AMENDMENTS TO THE DRAWINGS

The attached sheets of drawings include changes to the drawings. These sheets, which include Figures 1-4, replace the original sheets including Figures 1-4.

FIG. 2

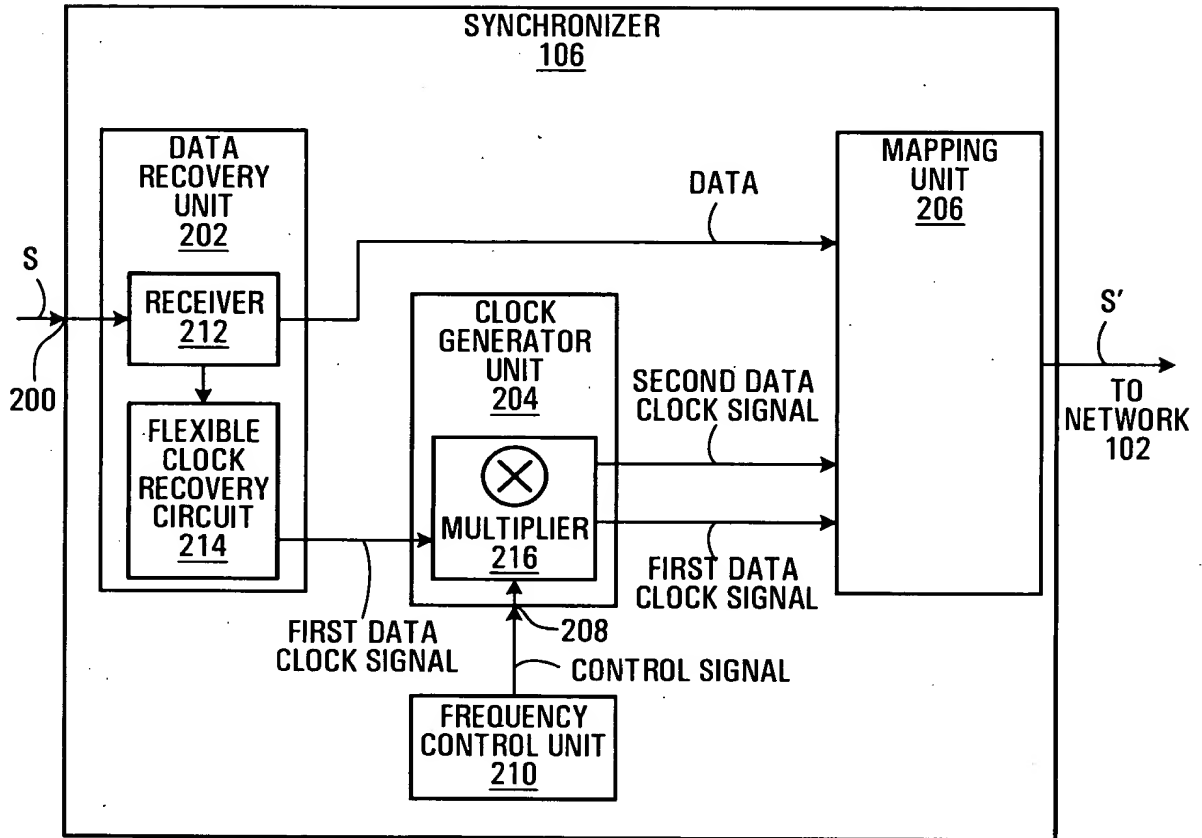
In Figure 2, the clock generator unit 204 has been labeled as such. In addition, the reference number of the multiplier has been changed from "206" to "216".

In Figures 2-4, labels "CLK2" and "CLK" have been replaced with the label "second data clock signal", and the label "CLK1" that appeared in Figures 2-3 has been replaced with the label "first data clock signal".

FIG. 3

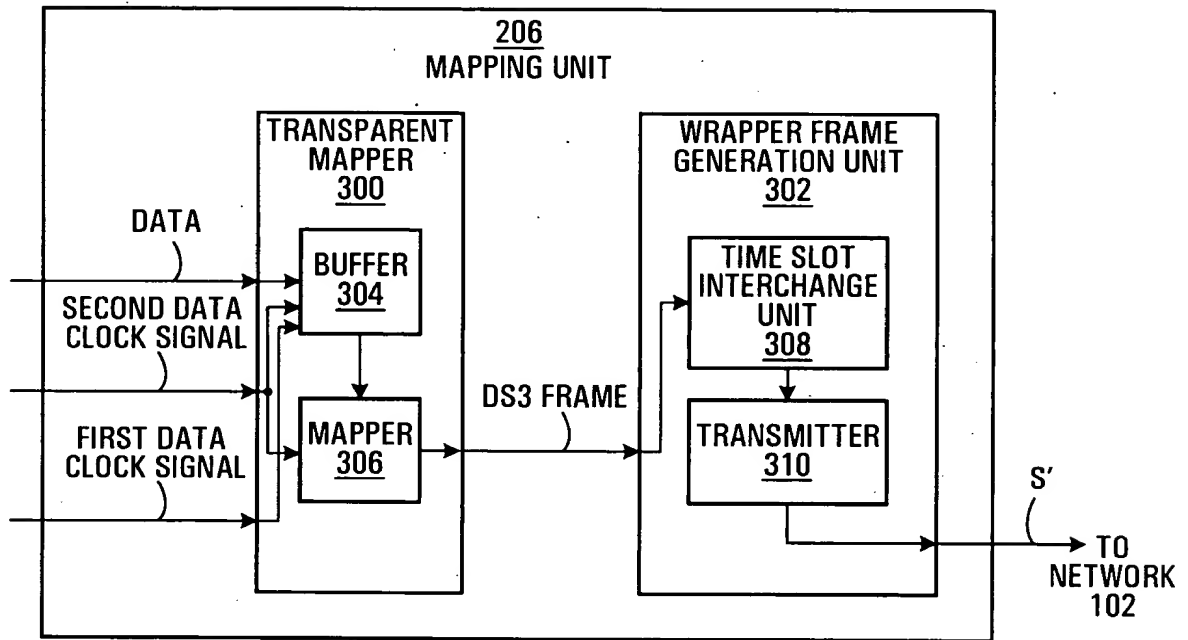
In Figure 3, specific inputs to functional elements 304 and 306 are now shown, as described in the specification. In Figure 4, specific inputs to functional elements 412, 414 and 416 are now shown, as described in the specification.
